DRAFT

~~August 11~~ September 21, 2009

Global technical regulation No. xx

HYDROGEN POWERED VEHICLE
(Established in the Global Registry on [DATE])

Figure 4. Typical Liquefied Hydrogen Storage System

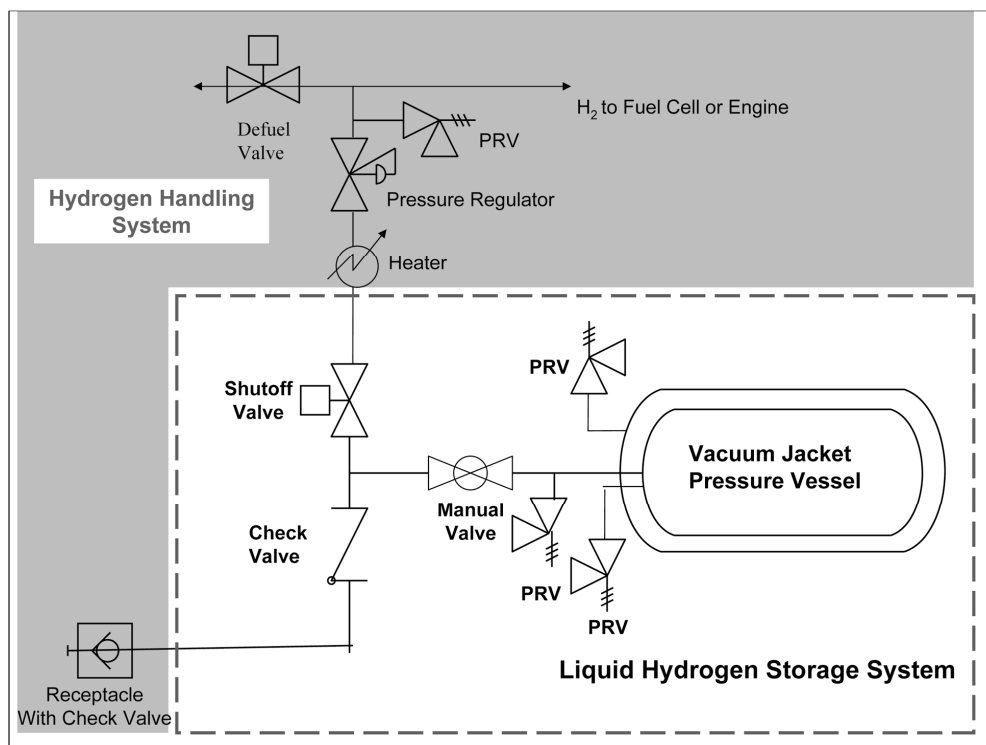
3.2.1 LIQUEFIED HYDROGEN STORAGE SYSTEM ([put in separate section](#))

Figure 5.1.1 Generic Hydrogen Storage System

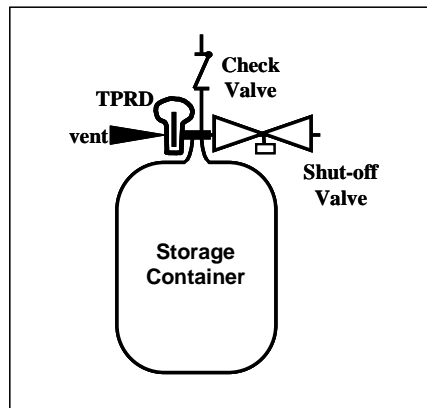
GS - Need definitions for storage components: temperature-activated pressure relief device(s) (TPRD), check valve(s), shut-off valve(s)

Figure 5.1.2.2.1 Verification Test for Performance Durability

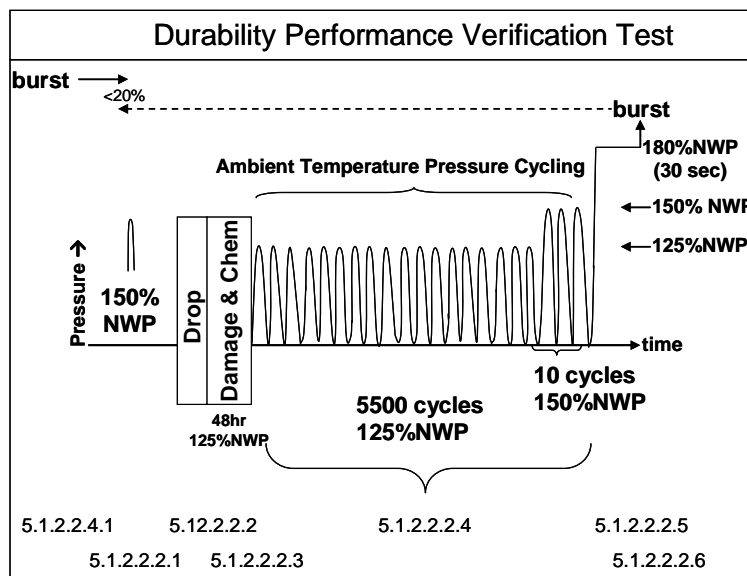
- How many containers have been tested in this requirement? Provide PowerTech report.

Figure 5.1.2.2.2 Verification Test for Expected On-Road Performance (pneumatic)

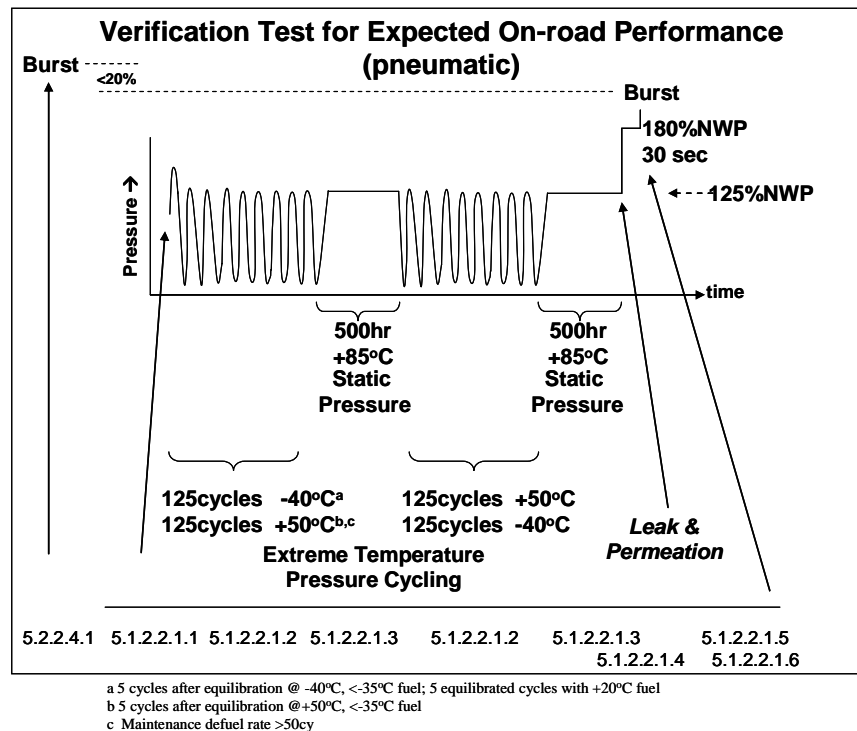
• ~~Comment by TUV: Is one sample sufficient to provide reliable results on the system performance?~~

SGS-6 Discussion: Conformity of production is ensured by the batch and routine test to ensure that the design qualification test is representative. Batch and routine tests will be added according to SAE J2579.
